**From:** Saxton, John  
**Sent:** Friday, March 28, 2014 8:39 AM  
**To:** StrataRossLA Resource  
**Subject:** FW: Strata Ross ISR Revised Technical Report  
**Attachments:** Ross\_TR\_Replacement\_Pages\_February 2014.pdf; Ross\_TR\_Change\_Index\_February 2014.pdf

**From:** bschiffer [<mailto:bschiffer@wwcengineering.com>]  
**Sent:** Thursday, March 27, 2014 5:15 PM  
**To:** Saxton, John  
**Cc:** Mike Griffin; Moore, Johari  
**Subject:** Re: Strata Ross ISR Revised Technical Report

### Technical Report Change Index

TECHNICAL REPORT  
FIGURE 4.2-1

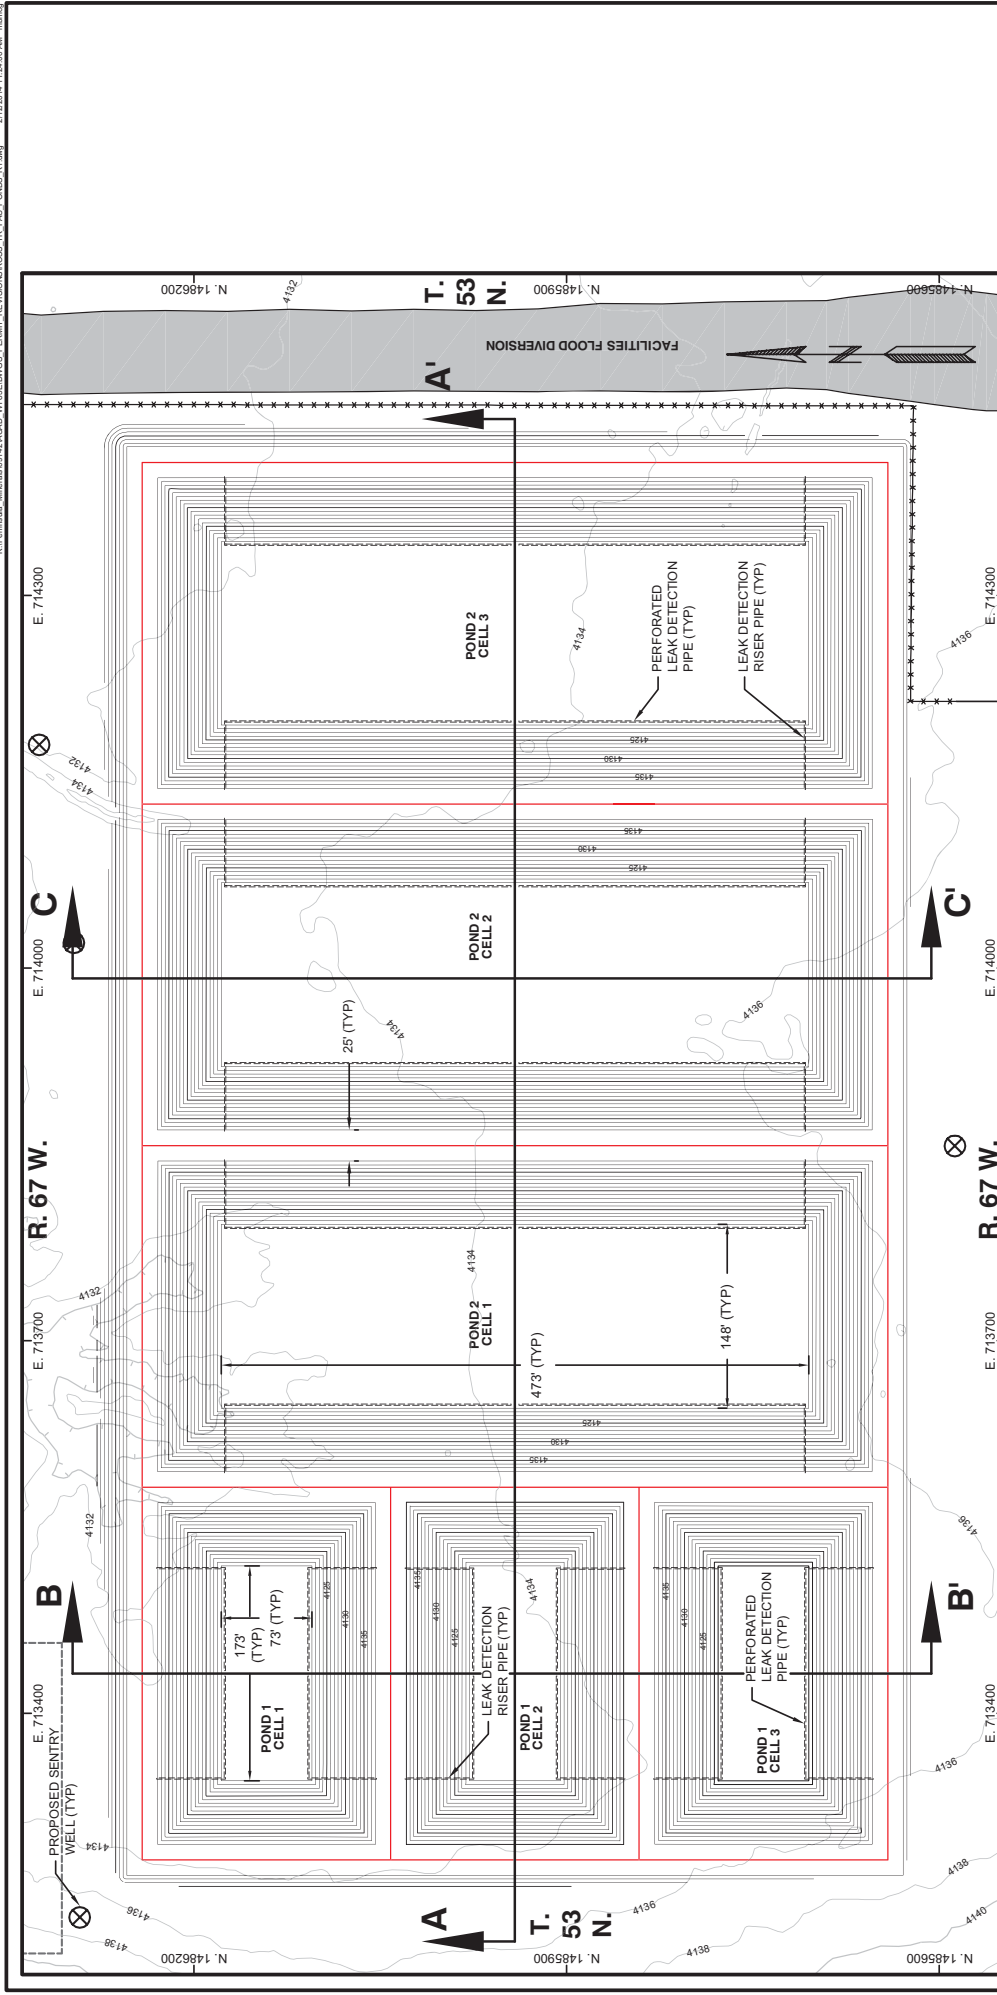
Lined retention ponds will be designed to meet the requirements of both NRC Regulatory Guide 3.11 for embankment retention systems and Wyoming Water Quality Rules and Regulations, Chapter 11, for lined wastewater storage ponds. The proposed pond designs will not be covered under the National Dam Safety Program because the proposed impoundments do not meet the criteria listed in NRC Regulatory Guide 3.11. The primary purpose of retention ponds is to manage permeate and brine inflows to optimize disposal techniques and provide for waste storage in the event of upset conditions. Sheet 1 of Figure 4.2-1 shows the location and layout of the proposed ponds.

TECHNICAL REPORT  
FIGURE 57-4

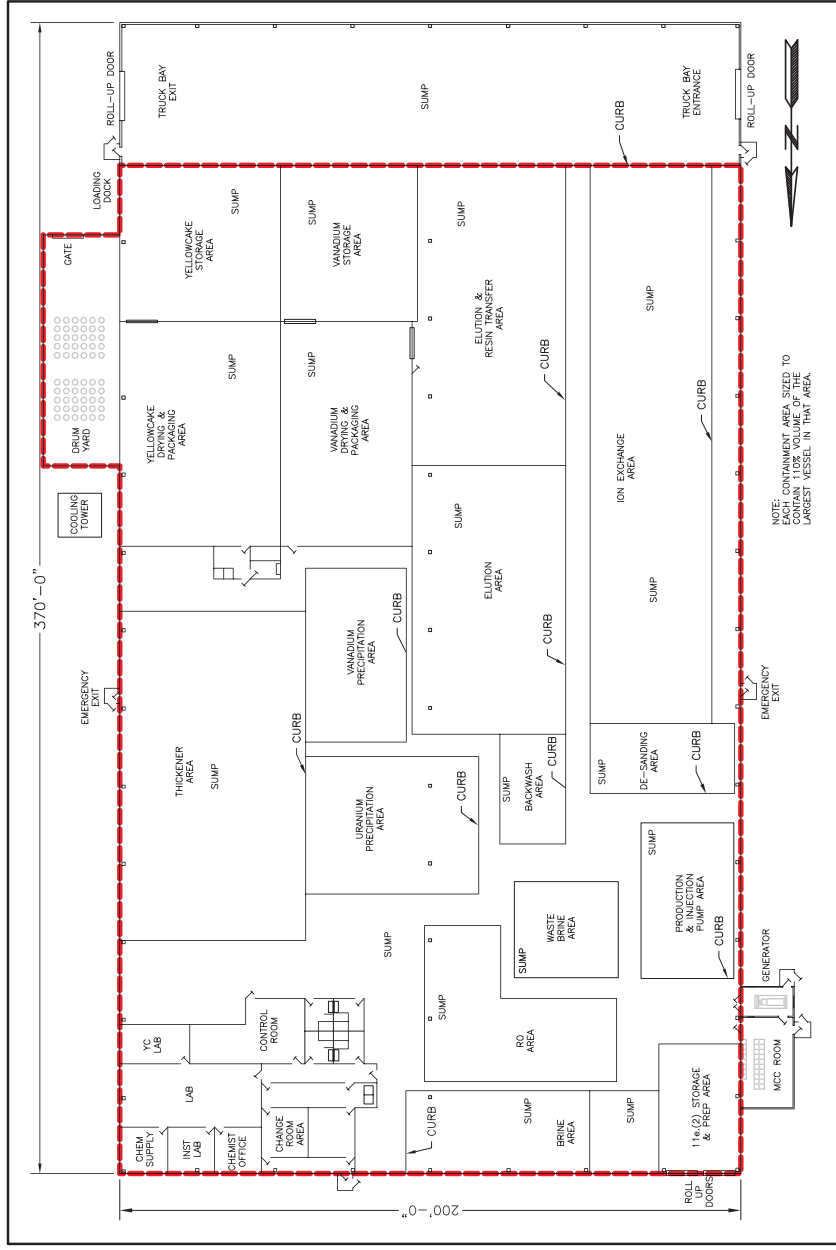
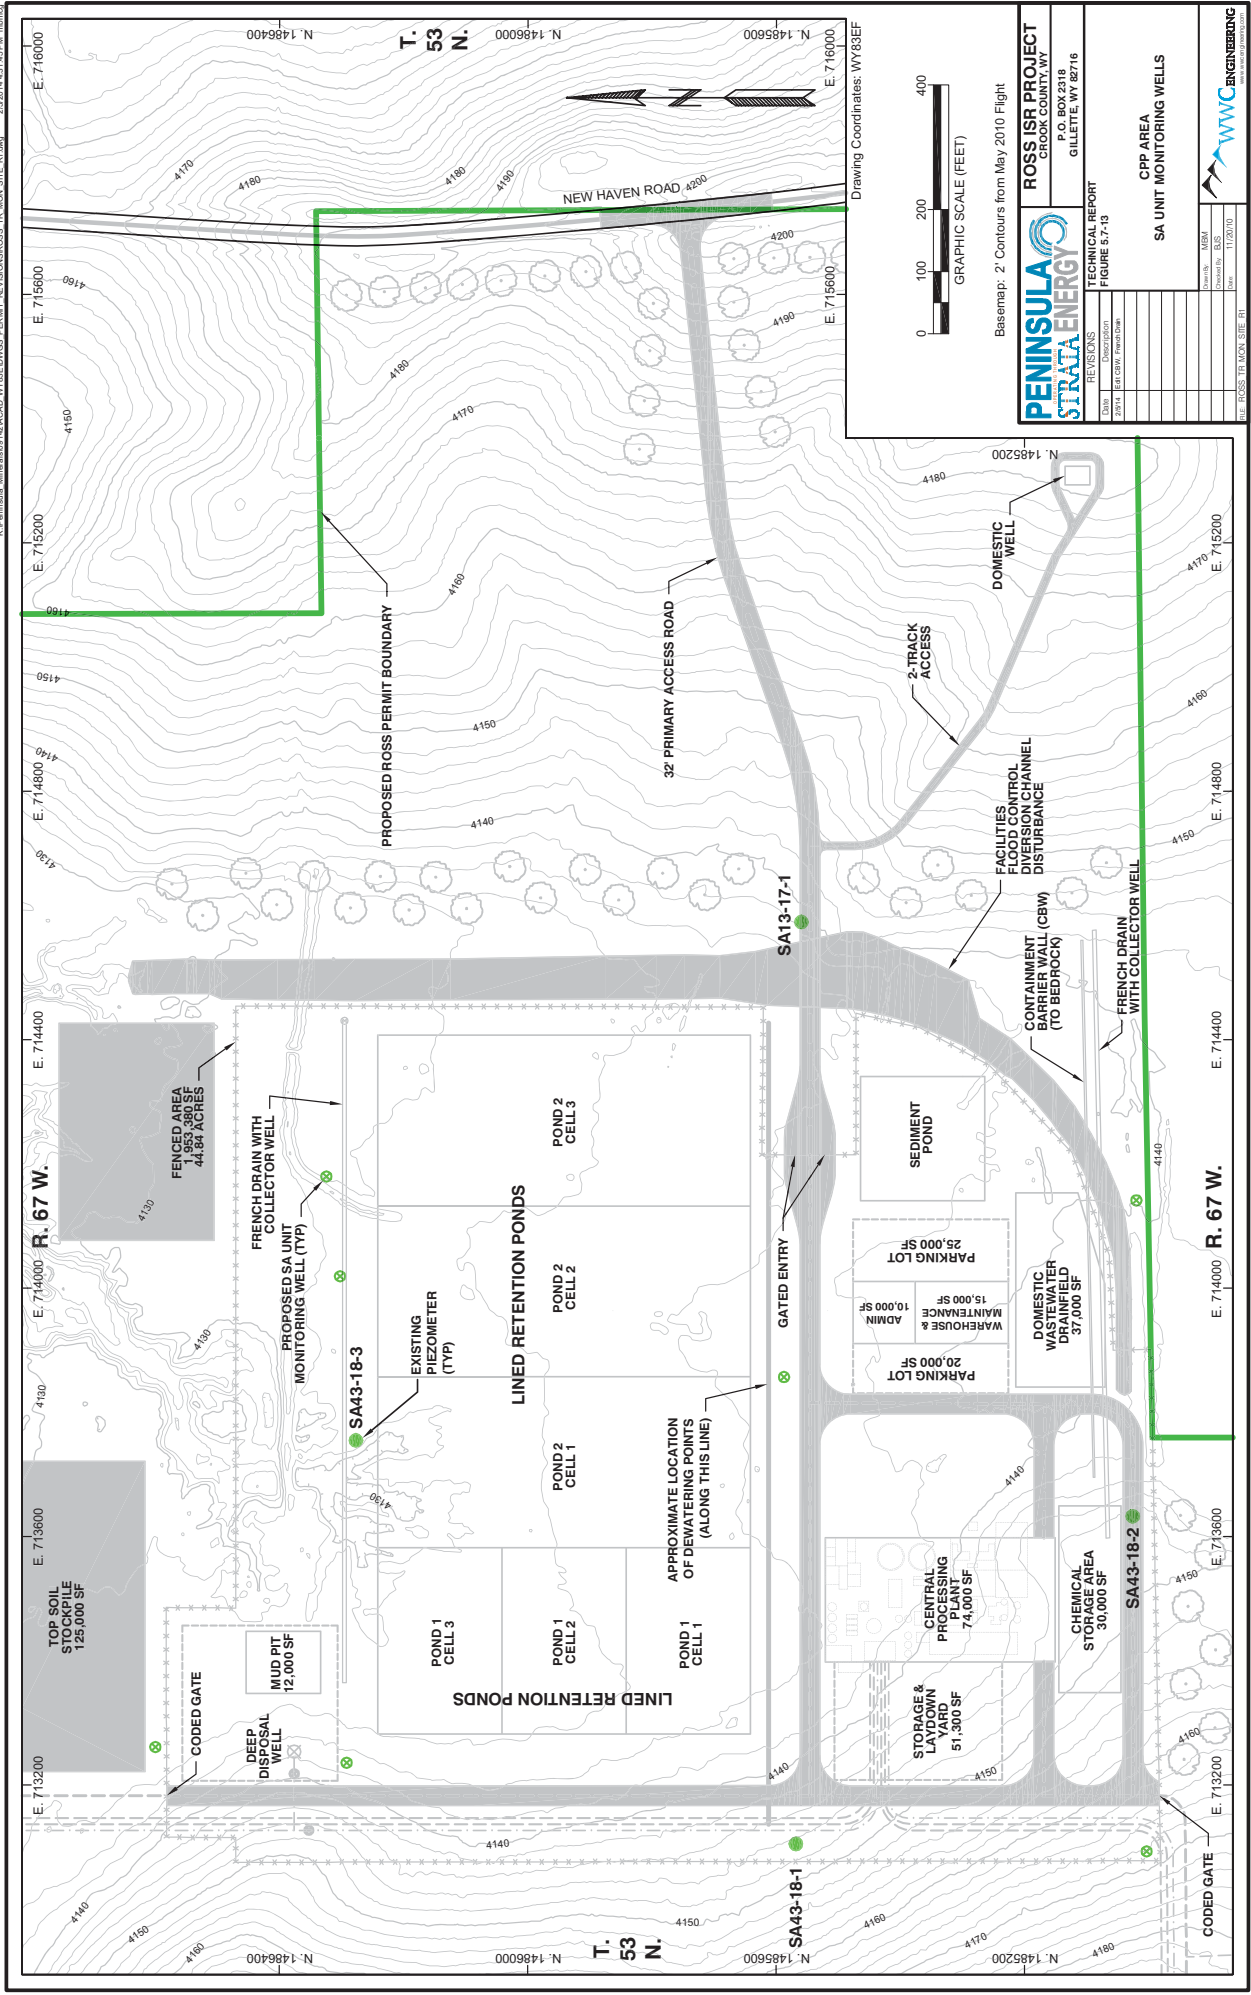
5-101	Figure 5.7-4	Revised CBW location and added upgradient french drain location	Final Design Modification
5-110	Figure 5.7-13	Revised CBW location and added upgradient french drain location	Final Design Modification
6-15	Sec. 6.1.5.1, ¶ 2, Line 3	Changed "would" to "will"	Correction based on Draft License Condition 9.2
6-24	¶ 1, Line 1	Changed "would" to "will"	Correction based on Draft License Condition 9.2
6-43	Sec. 6.2.6, ¶ 1, Line 2	Changed "surrounding" to "at"	Final Design Modification
6-43	Sec. 6.2.6, ¶ 1, Lines 6 & 7	Deleted "up-gradient and down-gradient reaches of the"	Final Design Modification
6-43	Sec. 6.2.6, ¶ 1, Lines 7 & 8	Deleted the following sentence "A "one-pass" trencher, very similar to that used to construct the CBW, will be utilized to install the finger drains."	Final Design Modification
6-43	Sec. 6.2.6, ¶ 1, Line 11	Deleted "During the "one-pass" operation"	Final Design Modification

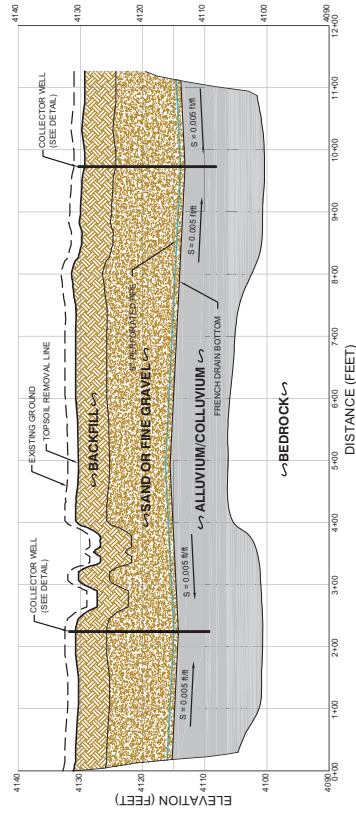
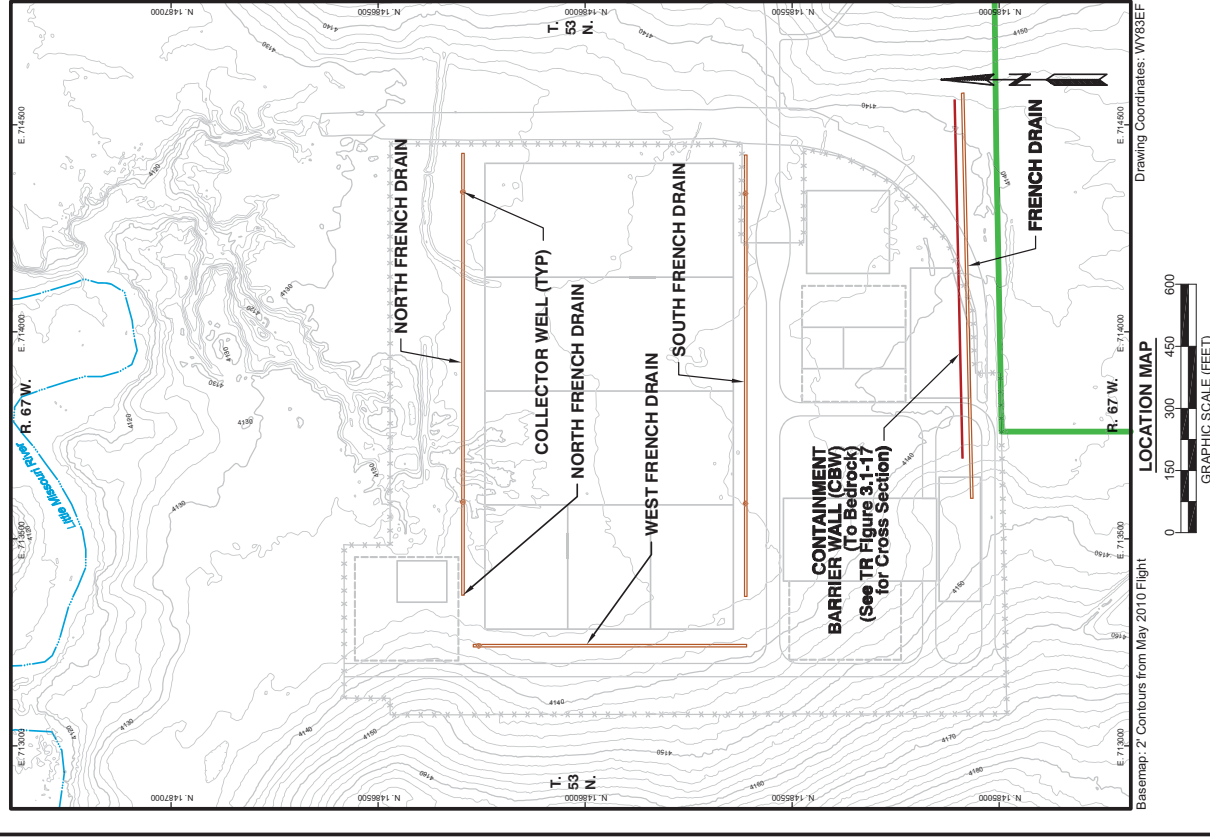
Figure 6-1 provides the approximate alignment of the CBW. The depth will range from approximately 4 feet to approximately 35 feet. The depth and extents of the CBW were estimated from borehole data and from piezometers installed in May 2010 and August 2011. Cross Section A-A (Figure 2) of Attachment A provides a geological cross section along the CBW. Bedrock intercepts were interpreted from the logs and used as the basis for the variable CBW depth.

The proposed CBW alignment runs along the south edge of the CPP area as shown on Figure 6-1. The CBW is not currently planned around the entire CPP area because boreholes indicated that bedrock along the east and west sides of the site are generally shallow (within 3-5 feet of the existing ground).

The CBW will be tied into the shallow bedrock on the east and west sides, effectively creating a dam to shallow groundwater flowing into the site. The north end of the CPP site is hydraulically downgradient from the CPP and CBW and should therefore contribute little groundwater flow to the site. Although some infiltration of surface runoff can be expected from the facilities flood control diversion during storm events, it will be minimal and will easily be handled by the dewatering infrastructure proposed within the CPP area. In addition, operational groundwater monitoring described in Section 5.7.8.2 will allow Strata to detect inflow from the east, west, and north sides of the site.
